# Evaluation of Construction and Plugging Procedures for Injection Well 357-7R at the CTV-Elk Hills Monterey Formation A1-A2 Class VI Project

This well construction and plugging evaluation report for the proposed Carbon TerraVault (CTV)-Elk Hills Class VI geologic sequestration (GS) project summarizes EPA's evaluation of several related activities associated with construction and plugging of the 357-7R injection well to inject CO<sub>2</sub> into the Monterey Formation A1-A2 Sands. These activities are described in the permit application narrative, and Attachment D to the permit application dated August 30, 2021, and an updated version of Attachment G (a file entitled Attachment G—Final), submitted on December 2, 2021. This review also identifies preliminary questions for the applicant. (Note that the permit application contains common information that applies to both injection wells planned for the project. Therefore, there is some repetition between this evaluation and EPA's evaluation of the attachments relevant to Well 355-7R. This is necessary to provide a complete evaluation for each Class VI permit record.)

*Table 5: Temperature profile and casing construction data for the 357-7R injector.*

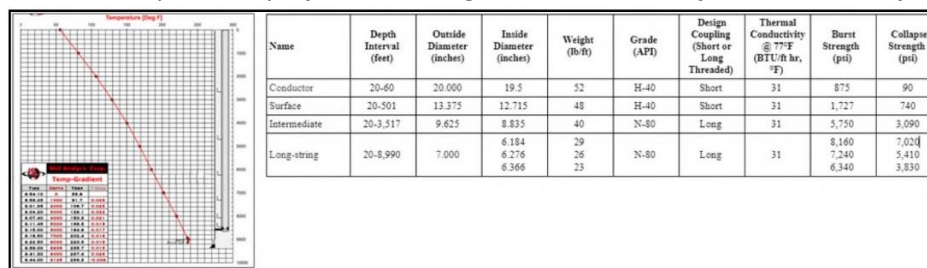
Table 5 of the Narrative, pictured above, corresponds to the casing specifications listed in Attachment G for Well 357-7R, pictured below. Attachment G also includes tubing and packer specifications for Well

357-7R, which are excerpted below. The tubing and packer specifications in Attachment G mostly correspond to Table 7 of the Narrative, however the packer burst strength (psi) and collapse rating (psi) differ between the documents.

- *Please reconcile the following differences between Attachment G and Table 7 of the Narrative:*
  - *The burst rating of the packer is 8,160 psi on Table 7 of Attachment A and 8,000 psi on page G3, and*

- *Attachment A, Table 5, and the Table on page G2 indicate that the intermediate casing in Well 357-7R is to a depth of 3,517 ft; on Table 6, this depth is 3,516 ft.*

- *The conductor casing material is H-40 in Attachment A, Table 5 and Attachment G, and it is J-55 in Table 6.*
  - *The surface casing material is H-40 in Table 5 and in Attachment G, pg. 2, and it is H-80 in Table 6.*
